Coffs Harbour Bypass

Submissions Report

Volume 1. Executive summary, Chapters 1-3

Figure 3.1-6 Coachmans Close cross section (section AA)

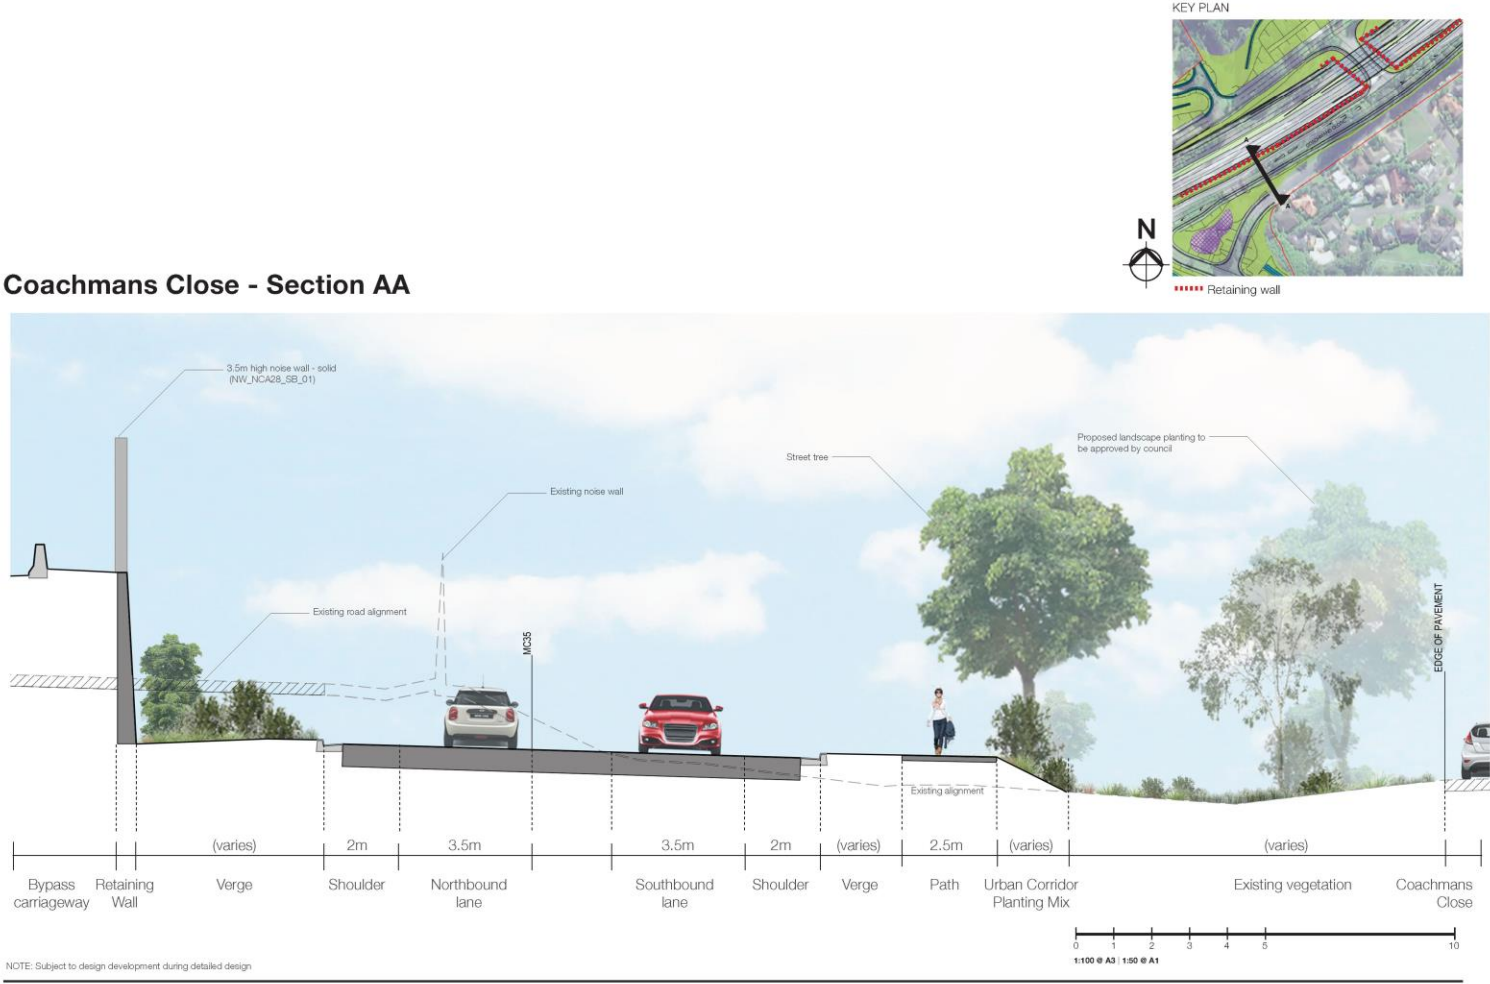
- Before and after artist's impression from two locations along Coachmans Close. The first is from the top of Coachmans Close looking towards the south (refer to **Figure 3.1-2** for the existing view and **Figure 3.1-3** for the view with the project). The second from near Fernleigh Avenue, looking towards the south (refer to **Figure 3.1-4** for the existing view and **Figure 3.1-5** for the view with the project)
- Cross-sections at two locations along Coachmans Close showing the relationship between Coachmans Close and the service road, including the width available for vegetation screening between the two roads (refer to **Figure 3.1-6** and **Figure 3.1-7**). These cross-sections highlight the varying width available for between the two roads, which range from about 10 metres at its widest and about 1.5 metres at its narrowest.

TfNSW acknowledges the vegetation within this area is of importance to the community and provides screening value. As illustrated in **Figure 3.1-33**, Coachmans Close north of Fernleigh Avenue, vegetation would be retained where possible to assist with screening views towards the project. During detailed design, an arborist assessment will be carried out to confirm the extent of vegetation that could be retained along Coachmans Close within the construction footprint (refer to

As the road descends to the south and the space narrows, it is anticipated that shrub planting would be provided to screen lower level views from the adjacent properties, as illustrated in **Figure 3.1-55**. As identified in environmental management measure UD01, an Urban Design Landscape Plan will be prepared to support the detailed design of the project. The plan will include identification of existing vegetation and proposed landscape areas, including areas along Coachmans Close. As part of this plan TfNSW will explore the opportunities to provide shrub planting in the form of a maintained hedge to allow the screening value to improve over time.

Figure 3.1-8 SEIA study area and Boambee East -Toormina area

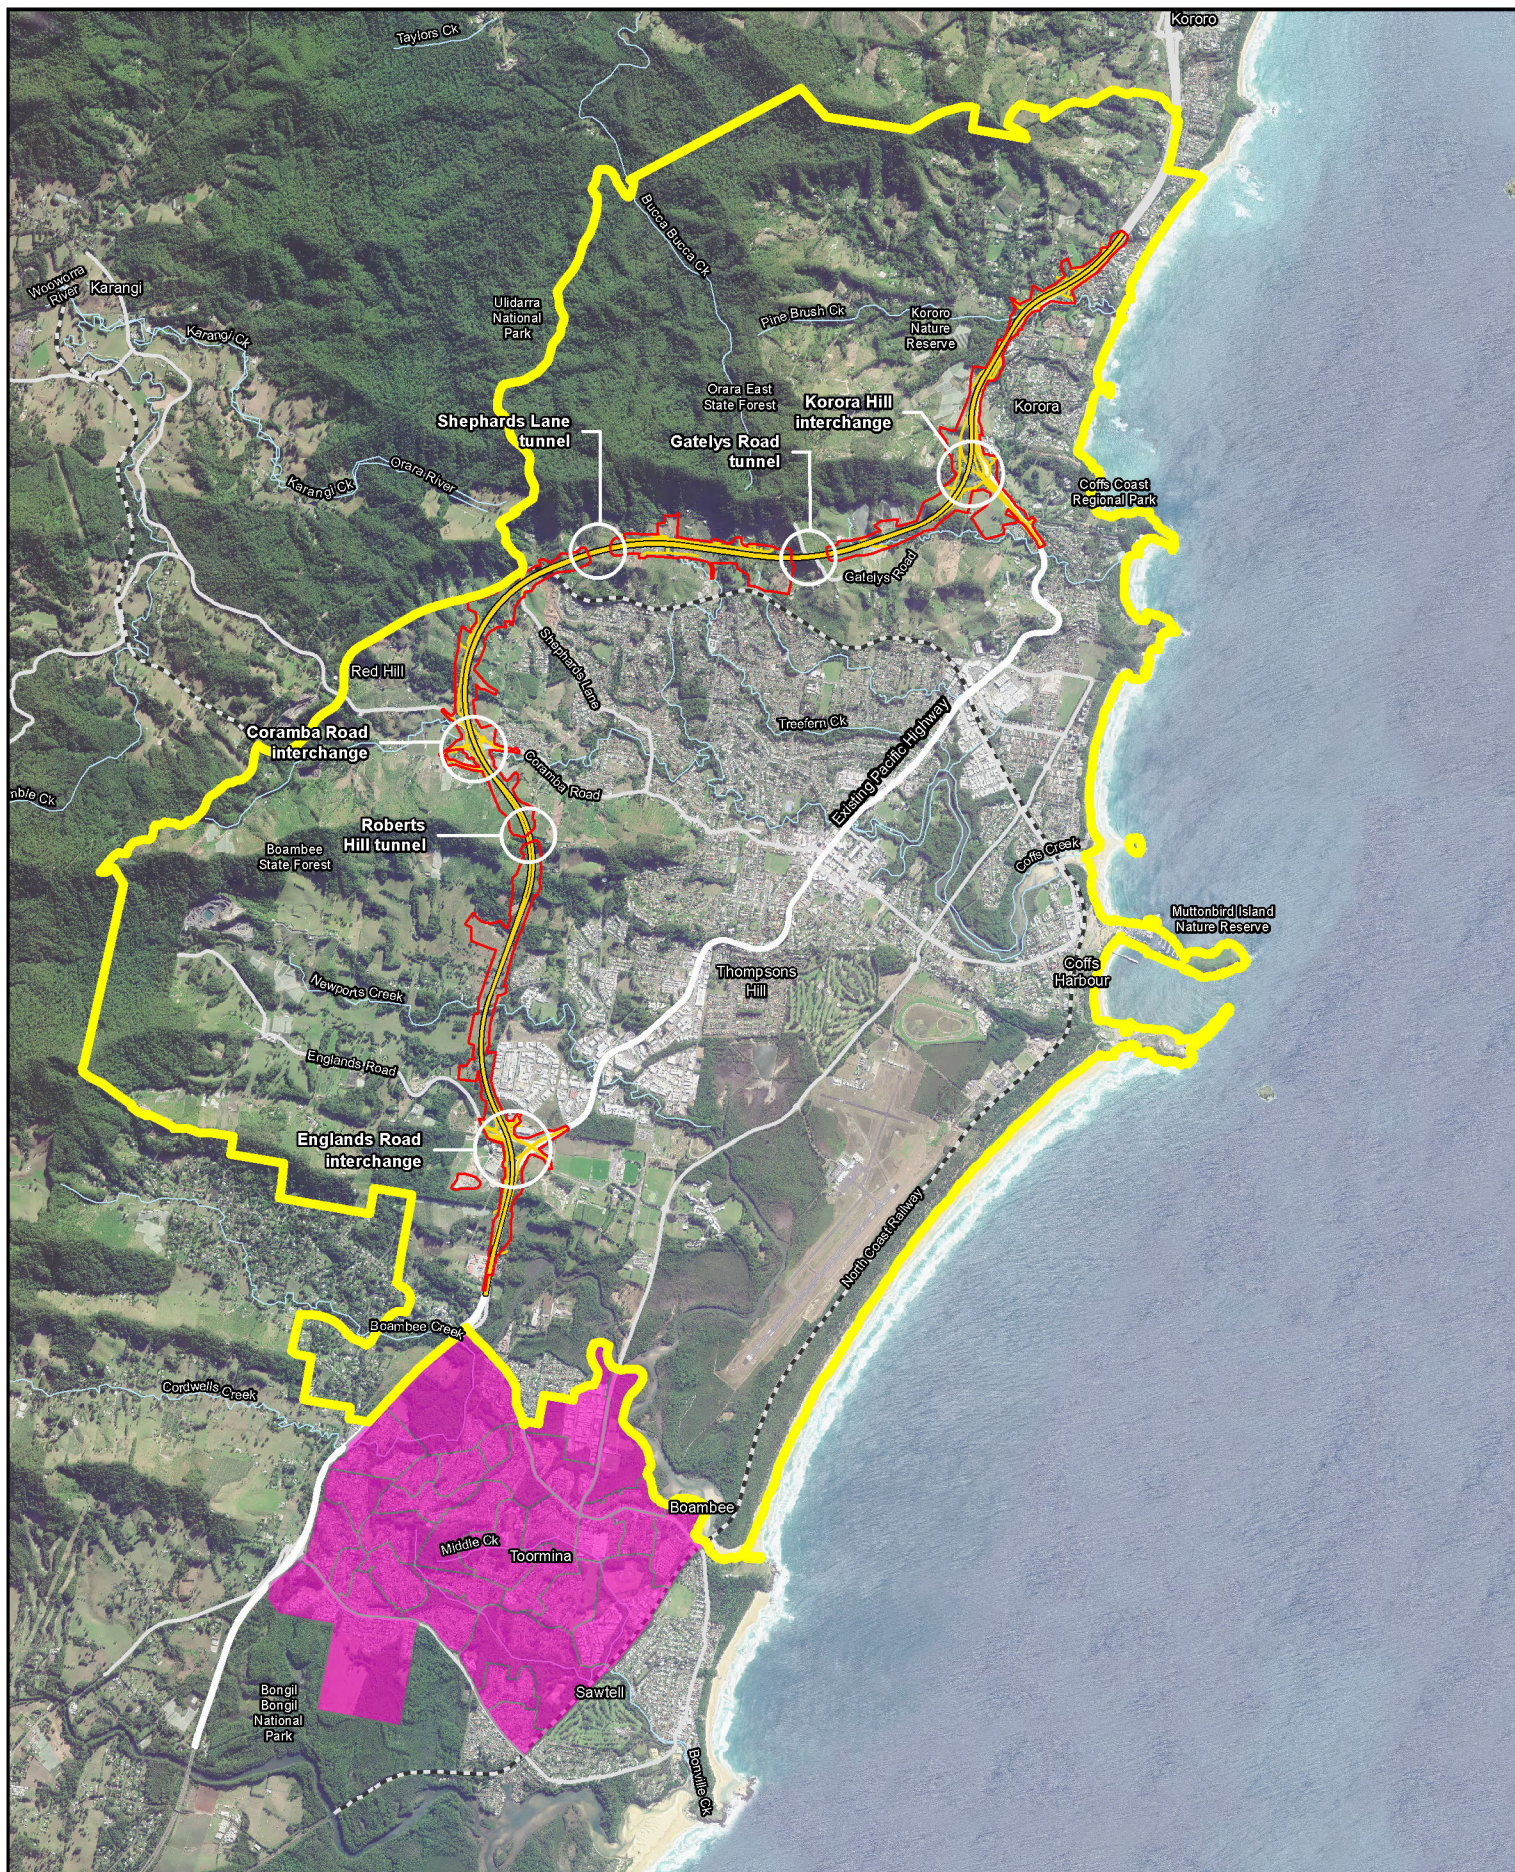
- The socio-economic impact assessment (SEIA) study area does not include residential areas and communities such as Boambee East, Toormina and the Northern Beaches. This is of particular relevance when understanding the potential impact on affordable housing and service provision across the Coffs Harbour LGA. Figure 14-4 of the EIS indicates areas near to the SEIA study area boundary that are in the lower decile of disadvantage. Potential impacts on these areas from the project should be considered. It is acknowledged that some data and associated analysis is compared at the local government level and State level, but key service and community areas appear to have been excluded from the broader analysis and impact assessment

However, to address CHCC's concerns regarding the potential social and economic impacts of the project in this area, additional assessment has been carried out for the Boambee East-Toormina area (shown in **Figure 3.1-8**). The Northern Beaches (Sapphire Beach and Moonee Beach) are more than 1.5 kilometres and six kilometres north of the project respectively, and these communities are unlikely to be impacted by the project. It is noted that the project would improve access and connectivity between the northern beaches and the SEIA study area, which contain social services and facilities which serve these communities.

The Boambee East-Toormina residential communities (as shown in **Figure 3.1-8**) span across 32 SA1s. The 2016 census recorded 11,397 people living in the Boambee East-Toormina area, split fairly evenly between males (48 per cent) and females (52 per cent). The median age of the population in the Boambee East-Toormina area was 42 years old, similar to the EIS SEIA study area of 43 years old.
